PIMA COUNTY REGIONAL FLOOD CONTROL DISTRICT TECHNICAL POLICY

POLICY NO.: Technical Policy, TECH-014

~~2015~~REVISED DATE: DRAFT 1/27/20

POLICY NAME: Erosion Protection of Stem Wall Foundations in Floodway Fringe Areas

FIGURE 014-A
EROSION PROTECTION OF LOAD BEARING PERIMETER STEM WALL IN FLOODWAY FRINGE AREAS

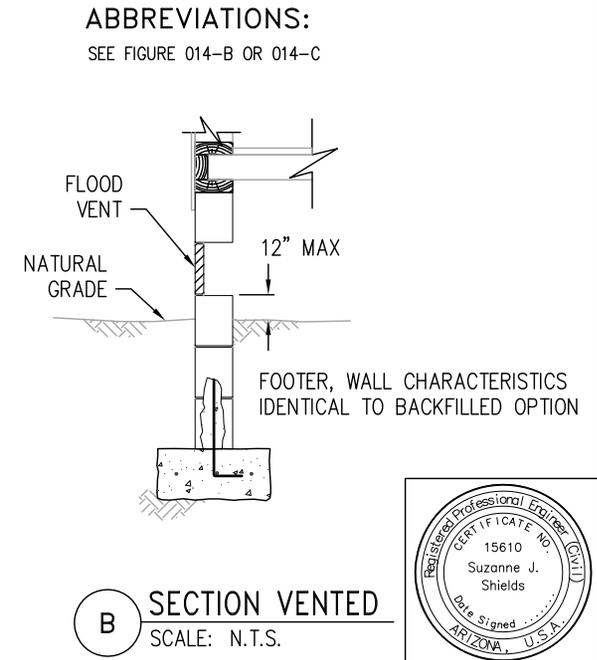
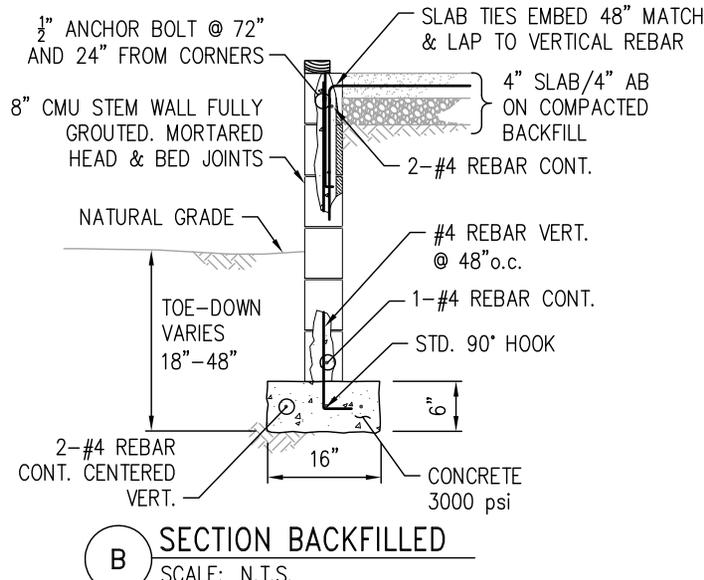
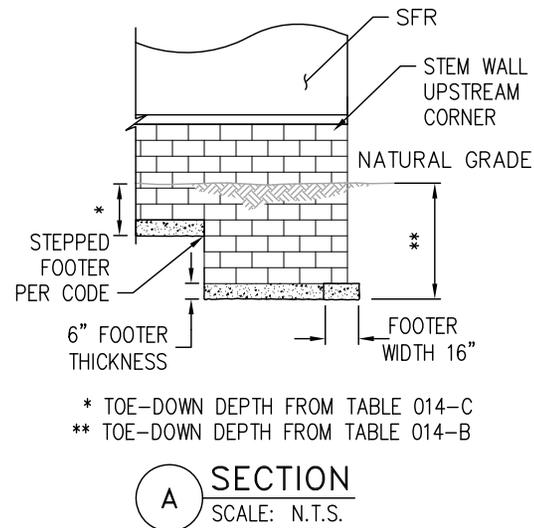
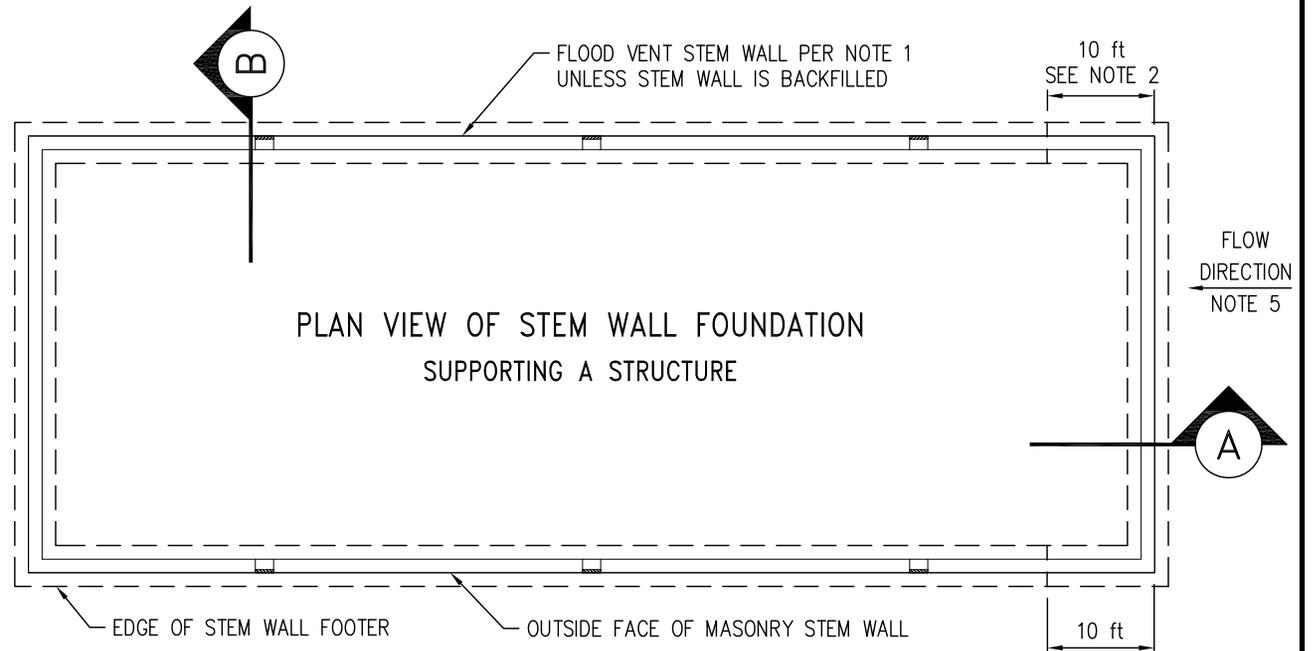
~~Figure 014-A Revised April 9,~~

- 5) Foundation scour protection for a stem wall foundation shall be accomplished- by:
 - a) Extending the bottom of the foundation footer down to the toe-down depth specified by Table 014. Toe-down depth shall be referenced to natural grade beneath the perimeter of the foundation. This scour protection is detailed in Figure 014-A.

FIGURE 014-B
HARDSCAPE OPTION FOR EROSION PROTECTION FROM ABUTMENT SCOUR
OF LOAD BEARING PERIMETER STEM WALL IN FLOODWAY FRINGE AREAS

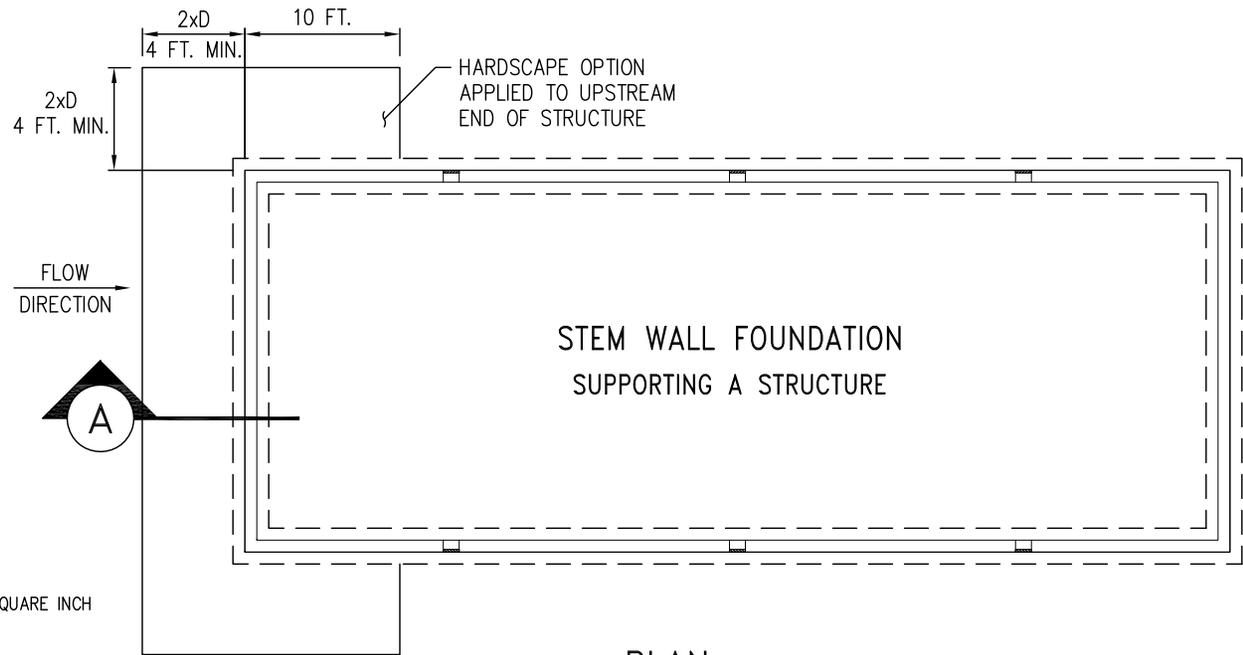
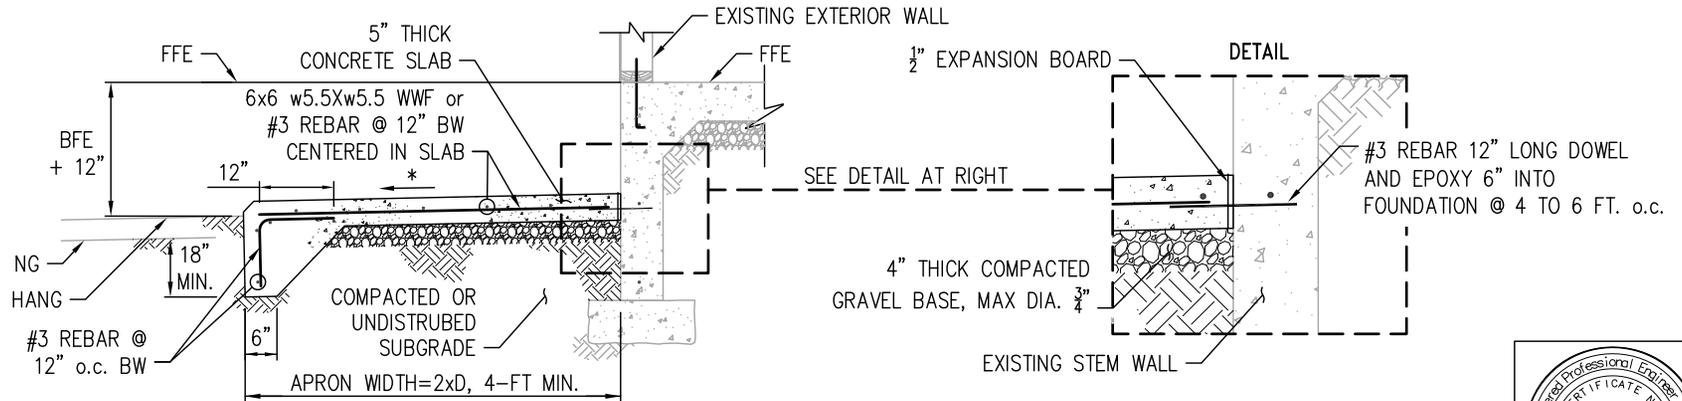
- b) Foundation scour protection from local (abutment) scour at the upstream end of an obstruction may be accomplished by the hardscaping option detailed in Figure 014-B.

FIGURE 014-C
RETRO FIT OPTION FOR EROSION PROTECTION OF LOAD BEARING PERIMETER STEM WALL IN FLOODWAY FRINGE AREAS

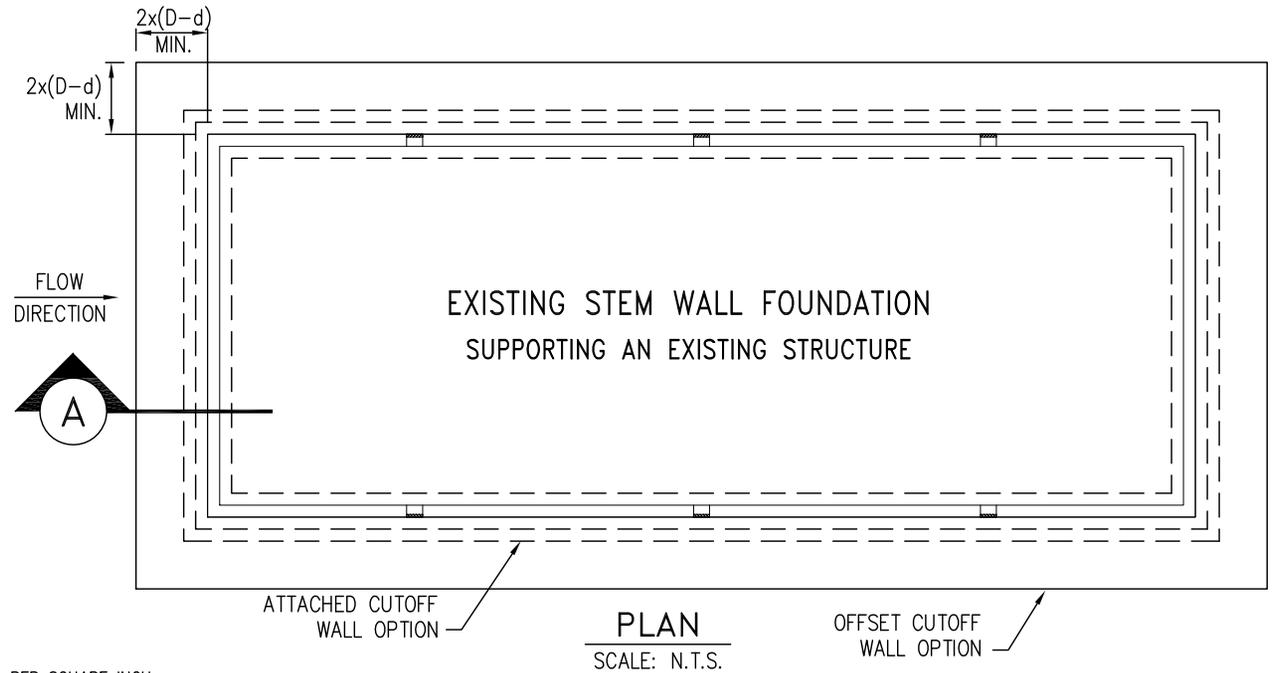
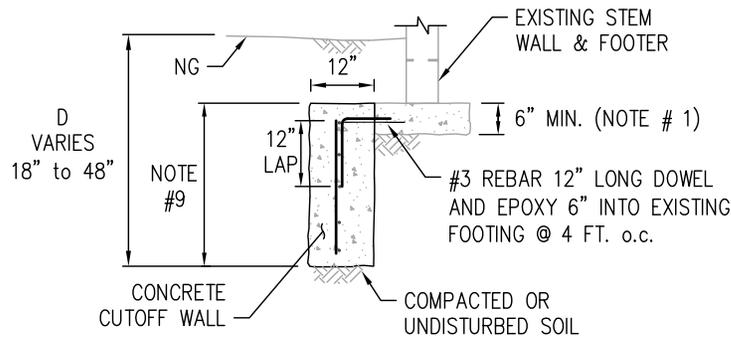
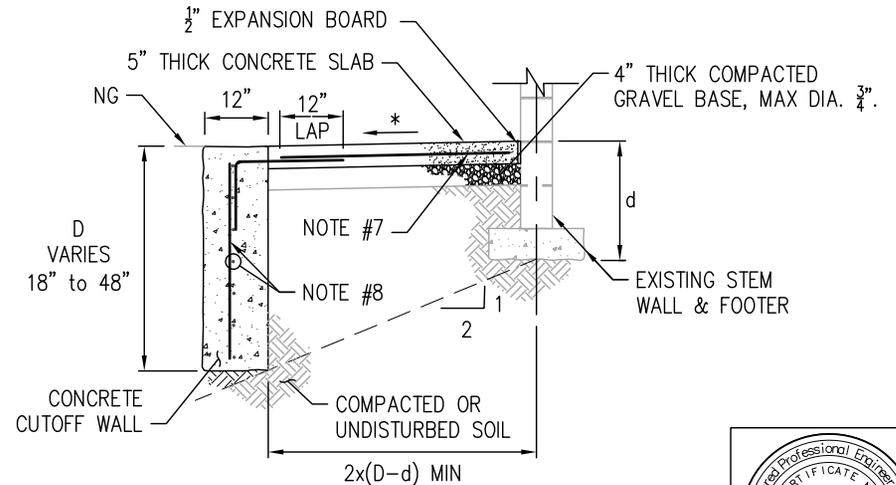
- c) Existing structures built without consideration for foundation erosion protection may have foundations retrofitted for erosion protection as shown in Figure 014-C.
